Re: Plan Commission Case PC 25-06  
Requesting approval of a Preliminary Plat of Subdivision with associated waivers in accordance with Chapter 12-8 of the Morton Grove Municipal Code, and a Special Use Permit for redevelopment to establish warehousing and light manufacturing uses at the properties commonly known as 8125-45 River Drive and 8120-40 Lehigh Avenue, Morton Grove, Illinois (PIN 10-20-303-001-000; 10-20-303-002-000), all within M-O/R Office/Research Manufacturing District per Section 12-4-4:E, with select waivers regarding setbacks, landscaping, signage, and parking located in a street side yard per Sections 12-2-6 and 12-4-4, and Chapters 10-10 and 12-11. The applicant is Midwest RE Acquisitions, LLC.

## STAFF REPORT

Re: **Appearance Commission Case AC 25-08**  
Request for approval of an Appearance Certificate for site, landscape, and building plans associated with Case PC 25-06, a request for a Special Use Permit for redevelopment to establish warehousing, distribution centers, and light manufacturing uses at the properties commonly known as 8125-45 River Drive and 8120-40 Lehigh Avenue, Morton Grove, Illinois (PIN 10-20-303-001-000; 10-20-303-002-000), all within M

**Proposed Site Plan**

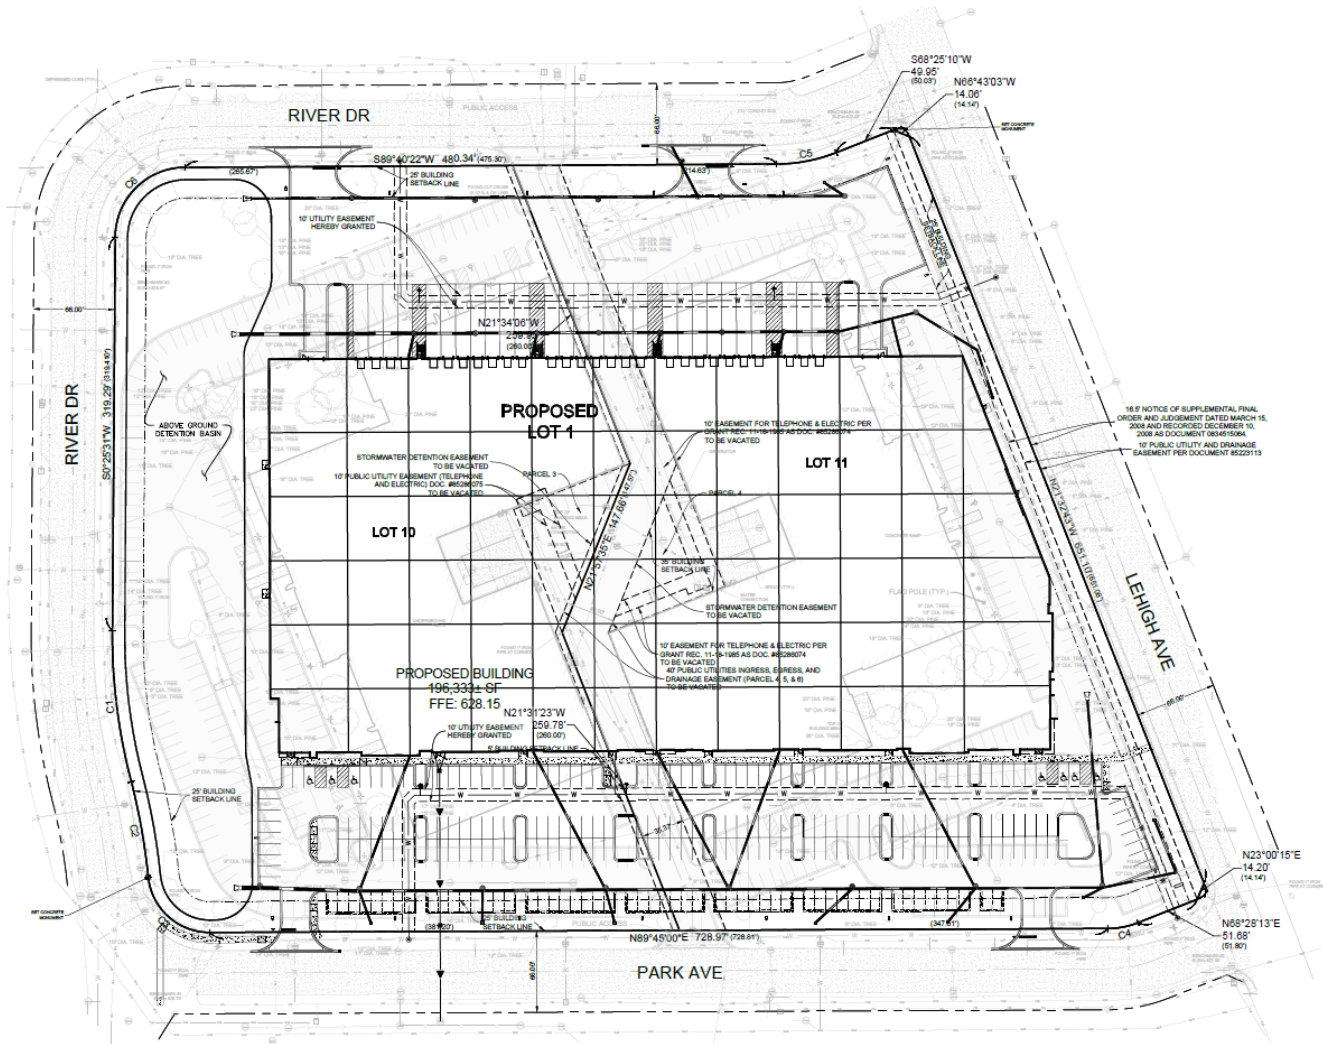
The site plan shows a differing sidewalk configuration with gaps between building entrances on the north façade. Staff believe the continuous sidewalk shown in the more detailed landscape plan and civil drawings reflects the intended sidewalk proposal.

***The applicant should speak to the proposed sidewalk alignment at the subject property.***

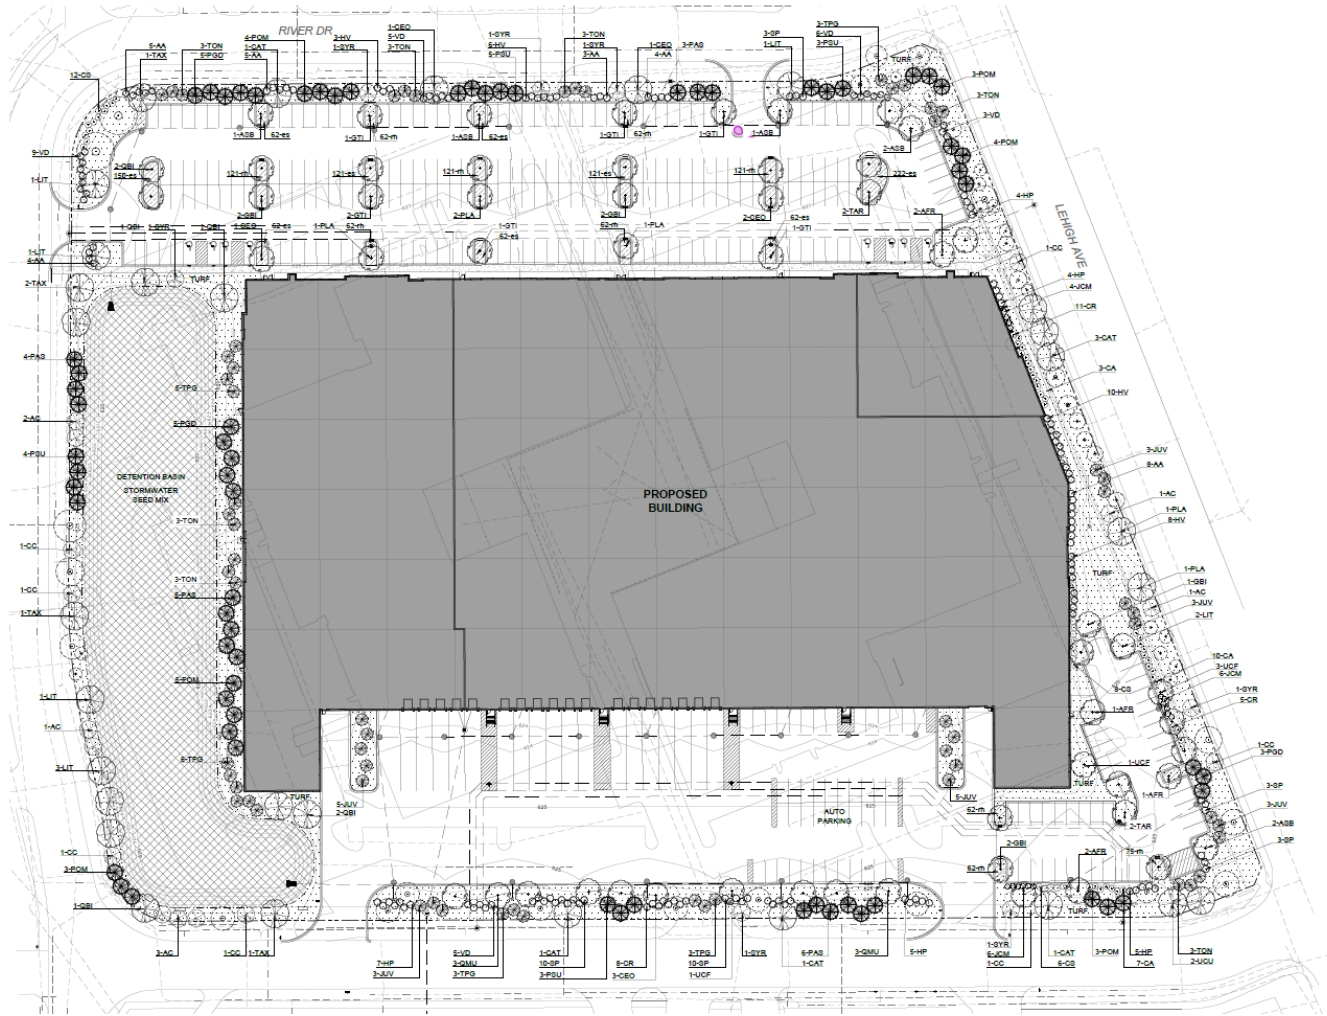
While replacement trees are proposed, the Appearance Commission noted concerns with the loss of established trees on the

site and the applicant has indicated that they will review the tree preservation plan to identify what additional trees could be saved. **The applicant should speak to efforts made to protect large, established and non-nuisance trees.**

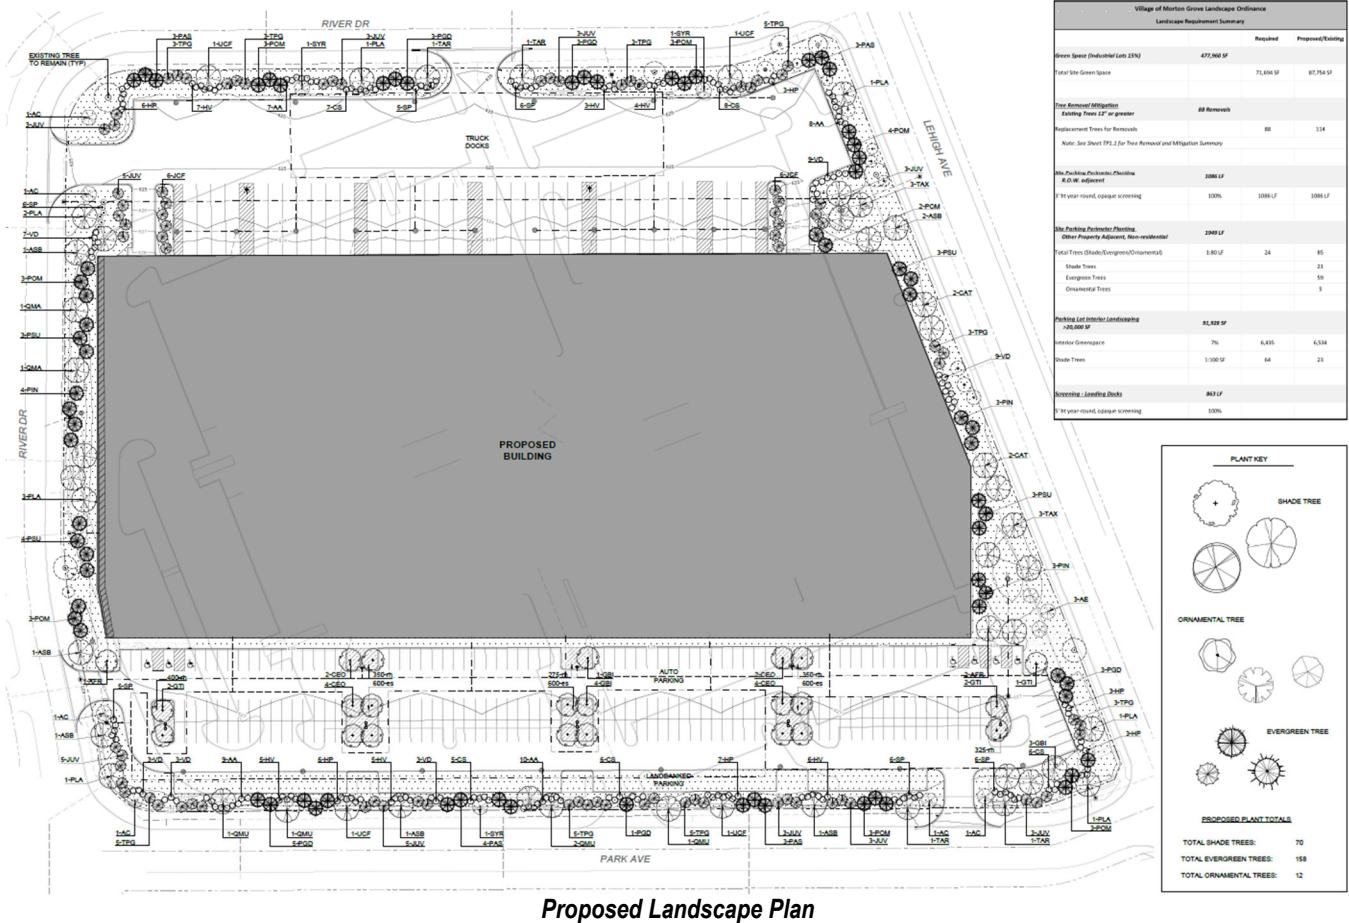
Only one (1) parkway tree is proposed. Per Section 12-11-2, parkway trees are to be installed every 40 feet which would result in a requirement of approximately 53 trees being planted in public right of way surrounding the subject property. The applicant has noted that utility locations inhibit the ability to plant trees in the parkway. Adjacent perimeter planting areas which are typically at least 25 feet deep are proposed to be used to accommodate trees in areas immediately adjacent the parkway. **The applicant should speak to presence of utilities and their proposed approach to providing adequate shade tree installation at the subject property.**

**Parking Lot and Entrance Lighting**

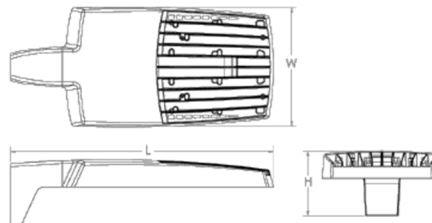
Per Section 12-4-3:B.5, the lighting of parking and loading areas shall be a minimum of one foot-candle on the surface. Per the submitted photometric plan, many of the parking stalls located between parking lot islands would have light levels of less than one foot-candle (1 ft-c). The building entrances also generally have low light levels. While lighting at the central entrance exceeds 1 ft-c, lighting at the west and east entrances ranges between 0.5 and 0.8 ft-c. **The applicant should speak to the types of lighting fixtures proposed in the photometric plan and address concerns regarding sufficient safety lighting.**

**Proposed Monument Sign Size (Left) and Location (Right – Labeled '1')**

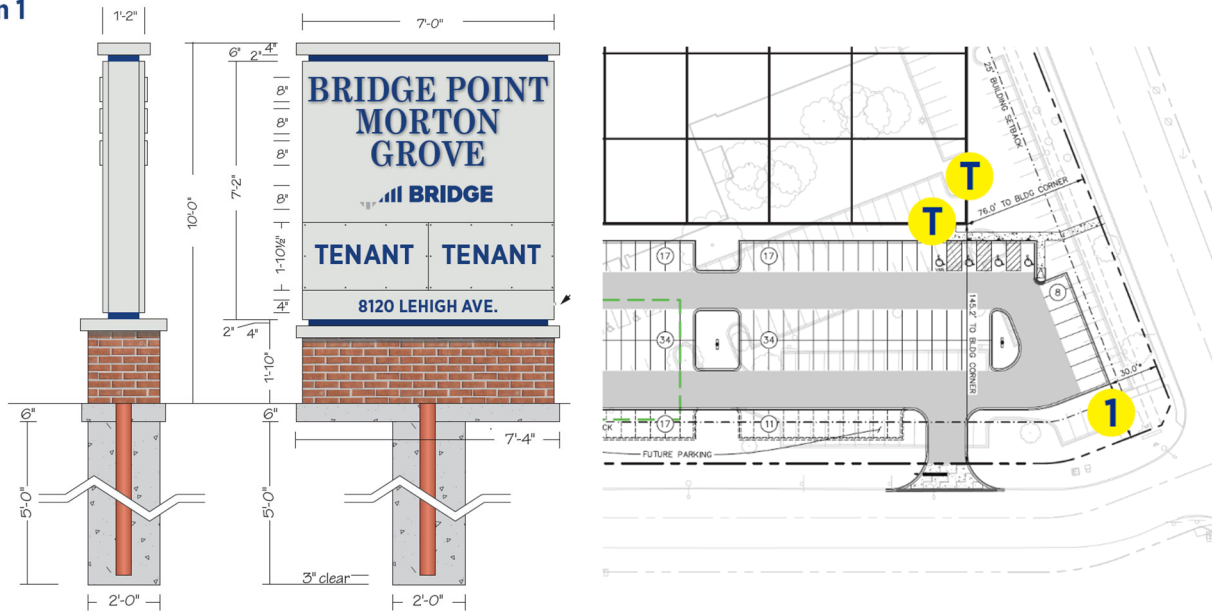
The proposed monument sign would be ten feet (10') tall with a sign area of 50.2 sq. ft. The proposed sign is required to be located at least five feet (5') from the public right of way along Park Avenue and Lehigh Avenue. The sign plan does not provide the precise location of the proposed monument sign, but there appears to be sufficient space for a compliant sign location given that the parking lot is located 30 feet (30') from either right of way. A landscape bed extending two feet (2') from the sign base is required, but not provided for in the sign plan. **The applicant should speak to the proposed sign location, proposed landscaping, and confirm whether related waivers are requested.**

**Proposed Address Sign**

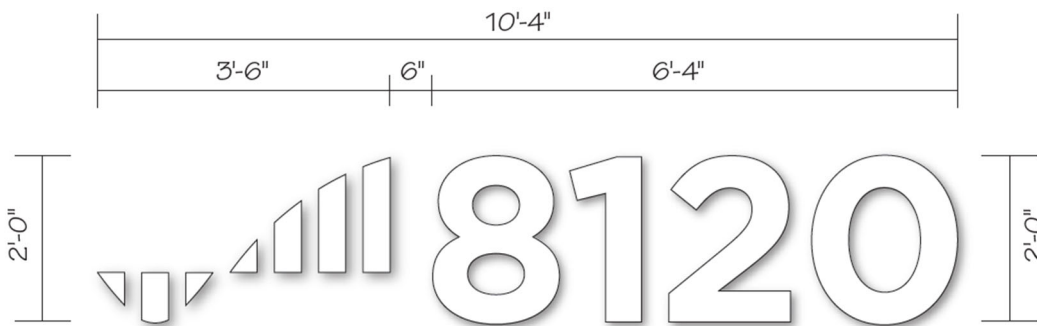
The address sign would consist of a Bridge Development logo and street number and would be 20.7 sq. ft. The address sign would be constructed of one inch (1") thick acrylic that is painted white and flush mounted to the building. The proposed sign is in excess of the two (2) sq. ft. maximum permitted, however Staff note that the sign size is proportional to the building and are not concerned with the request. Similarly sized address numbers are located on other industrial buildings in the area and the Bridge Development logo measures seven (7) sq. ft. which is smaller than tenant signage typically permitted.
